3.6.5 GLA - 7th January 2020

3.6.6 Pre-application 4 - 23rd January 2020

3.6.7 Pre-application 5 - 6th February 2020

Ground floor plan of proposals - Pre-application 4

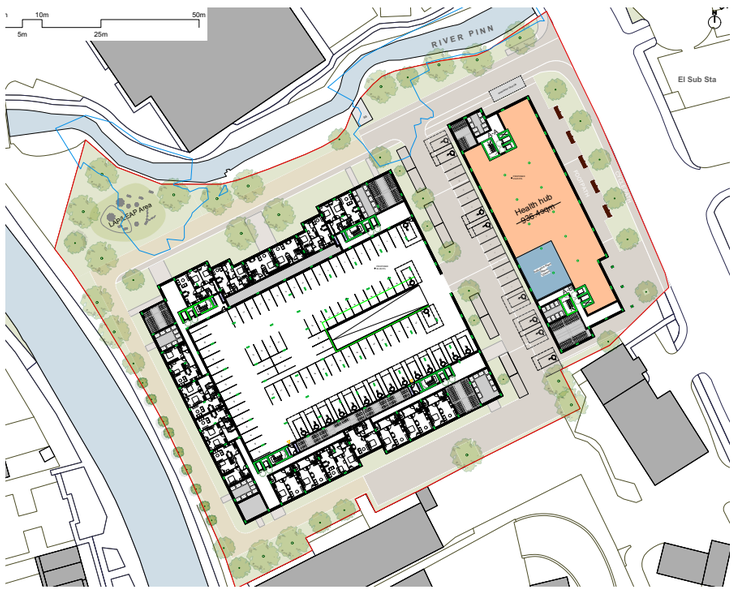
- Strategic meeting to discuss delivery of Health facility and timescales for opening and operations
- Quantum of Affordable Housing taking account of existing land uses - MOT Testing Centre confirmed as B2 use
- Flooding - ensure sequential test scope is borough wide as opposed to Yiewsley and West Drayton only

- Apollo to issue statement of support for Health facility
- Unit mix amended to include a further 7no. affordable units (35%-38% hab rooms)
- Sequential test undertaken - borough wide

Ground floor plan of proposals - Pre-application 5

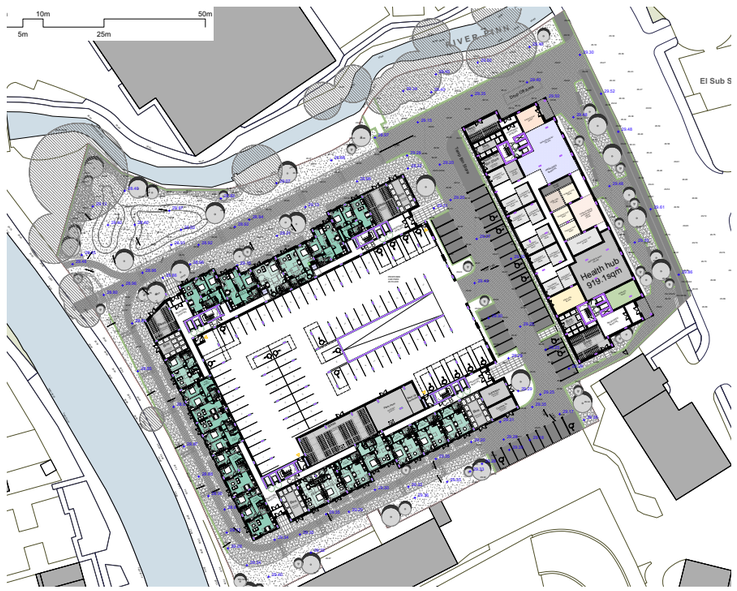
- Awaiting results from borough wide sequential test
- Landscape design well received - improved Celandine route a huge public benefit as current layout is through existing retail park / car park
- Transport and other technical matters agreed in principle
- Awaiting elevation design
- Energy strategy to be agreed with GLA

- Sequential test issued to LBoH
- Landscape developed alongside proposed site levels
- Ground floor 'pontoons' added to landscape strategy and shown on proposed elevations
- No BREEAM assessment required for Health Facility
